Access Compliance Report

Public Rights-of-Way

Intersection ID: N/A	Main Street: ELEANOR_RIGBY_RD	Cross Street: MAGGIE_MAY_LN	Location: NE
ADA ID: 9C05CB74B5B9	Ramp Type: Perp	Initial Pass/Fail: Fail	Overall Compliance: No
		Severity Score: 10

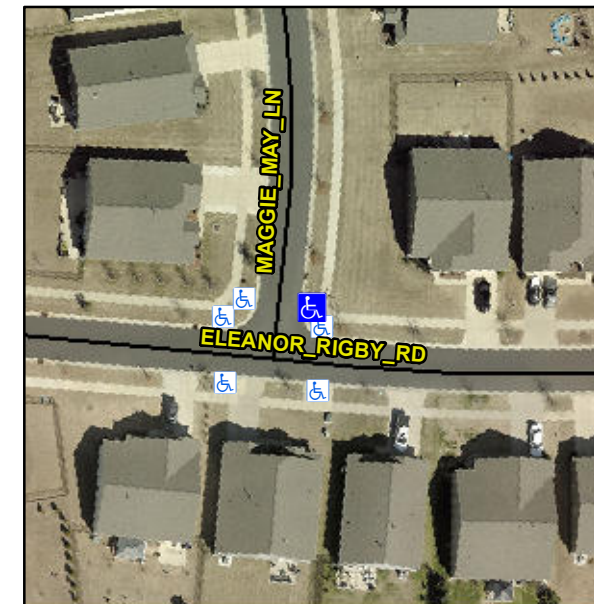
Not Found, R304.5.1, R304.5.3

Compliance	Description	Data	Compliance	Description	Data
N/A	Ramp Length (in)	88.0	Yes	Ramp Slope (%)	7.1
No	Ramp Width (in)	46.0	No	Ramp XSlope (%)	2.8
N/A	Flare Type LT	N/A	N/A	Flare Type RT	N/A
N/A	Flare Slope LT (%)	N/A	N/A	Flare Slope RT (%)	N/A
N/A	Flare Traversable LT?	N/A	N/A	Flare Traversable RT?	N/A
N/A	Landing Length (in)	N/A	N/A	DWS Provided?	N/A
N/A	Landing Width (in)	N/A	N/A	DWS Contrast?	N/A
N/A	Landing Slope (%)	N/A	N/A	DWS Length (in)	N/A
N/A	Landing X Slope (%)	N/A	N/A	DWS Full Width?	N/A
N/A	Landing Curb? (Y/N)	N/A	N/A	DWS Offset (in)	N/A
N/A	Shared Landing?	N/A			
N/A	Gutter Ponding?	N/A	N/A	Gutter Slope (%)	N/A
N/A	Gutter Lip Ht (in)	N/A	N/A	Gutter X Slope (%)	N/A
N/A	Painted X Walk1?	No	N/A	Painted X Walk2?	N/A
	X Walk 1 Direction	To NW		X Walk 2 Direction	N/A
N/A	X Walk 1 Width (in)	N/A	N/A	X Walk 2 Width (in)	N/A
	X Walk 1 Slope (%)	0.1		X Walk 2 Slope (%)	N/A
	X Walk 1 X Slope (%)	1.3		X Walk 2 X Slope (%)	N/A

Remove & Replace Entire Ramp.
